# UNITED STATES PATENT AND TRADEMARK OFFICE

APPLICATION NO.	FILING DATE	FIRST NAMED INVENTOR	ATTORNEY DOCKET NO.	CONFIRMATION NO.
10/781,088	02/17/2004	Robert J. Simmons	J-BSIM.1011	3395
56703	7590	06/13/2007		
ROBERT D. VARITZ, P.C. 4915 SE 33RD PLACE PORTLAND, OR 97202			EXAMINER WENDELL, MARK R	
			ART UNIT	PAPER NUMBER
			3609	
			MAIL DATE	DELIVERY MODE
			06/13/2007	PAPER

<b>Office Action Summary</b>	<b>Application No.</b>	<b>Applicant(s)</b>	
	10/781,088	SIMMONS, ROBERT J.	
	<b>Examiner</b>	<b>Art Unit</b>	
	Mark R. Wendell	3609

**DETAILED ACTION*****Priority***

**FIG. 6**

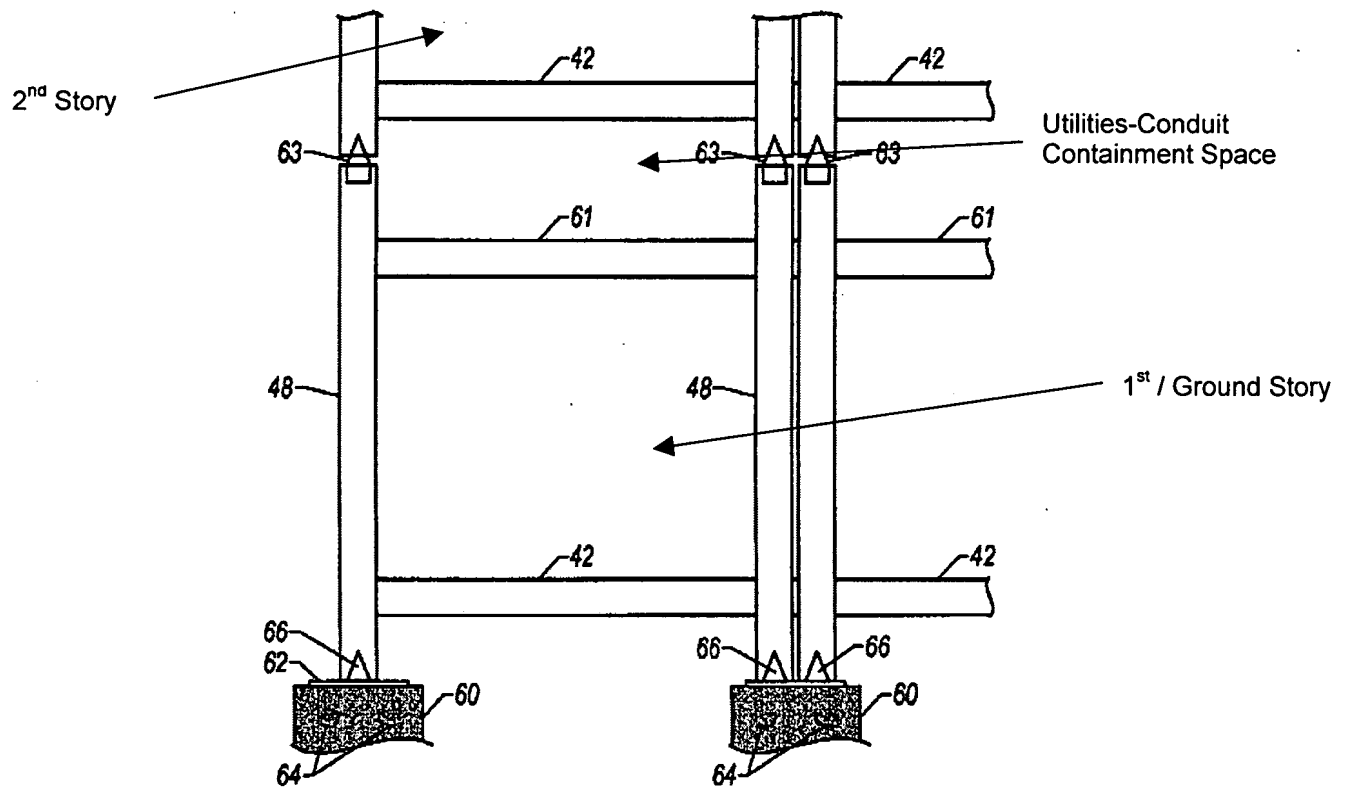
Claims 1-3, 6 are rejected under 35 U.S.C. 102(e) as being anticipated by Parker et al. (US 6625937). Parker illustrates in Figures 3A and 6 a plural-story building comprising:

- A pair of vertically spaced stories including a lower and higher story, each having a normal full-plate height and volume (see modified Figure below); and,
- A utilities-conduit containment space in between the lower and higher stories (see modified Figure below).

Regarding claim 2, Parker discloses that the containment space is built with support beams (61) made from steel. It is notoriously well known within the art of building construction that steel is water impervious. Therefore the containment space, with its underlying steel supports, is "appropriately lined" (with the metal support lining the floor) against liquid drainage to the lower story.

Regarding claim 3, Parker illustrates in Figure 6 and discloses in Column 5, lines 7-10, the lower story being a ground level story.

Regarding claim 6, Parker illustrates in Figures 3A and 6 a plural-story building comprising:

- A vertical stack of stories including plural normal-height stories (see modified Figure above);
- A less-than-normal-height sub-story with an internal volume (see modified Figure above).

The examiner notes that the sub-story of Parker is “adapted to contain utilities conduit structure.” The phrase “adapted to” is vague and the examiner notes that the sub-story of Parker could house utilities, or utility conduits.

Figures 4 and 5 of Douglass, Jr.

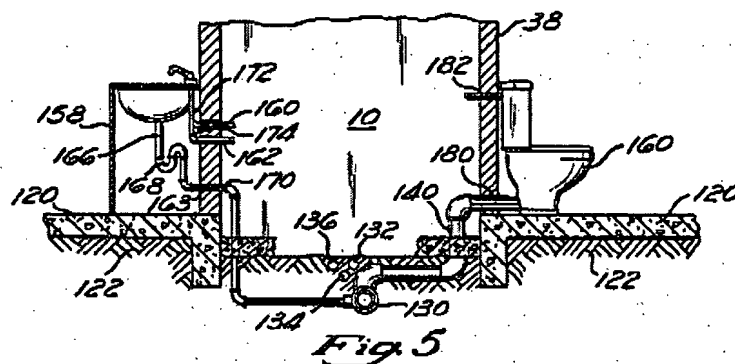
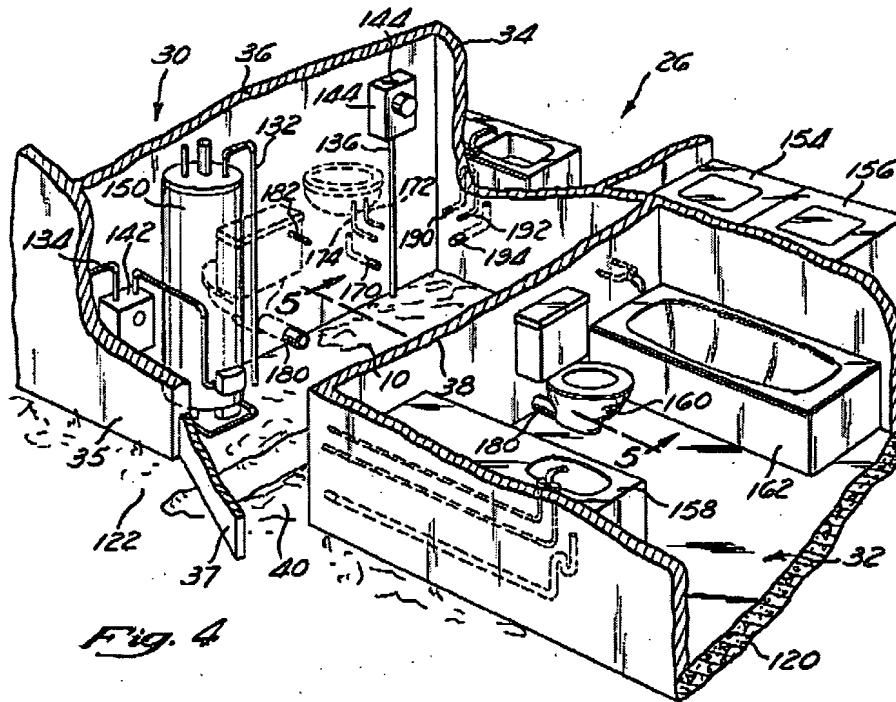
claims 1-3 and 6 what is disclosed, or illustrated, in Parker. Parker does not disclose a utility-conduit structure within the containment space that includes supply-input portions. However, Douglass illustrates in Figures 4 and 5 a containment space (30) with utility supply-input portions (160, 162, 170, 140). It would have been obvious to one of ordinary skill in the art at the time of invention to modify the containment space of Parker to include the utility supply-input portions of Douglass with the motivation of providing utilities to an adjacent room.
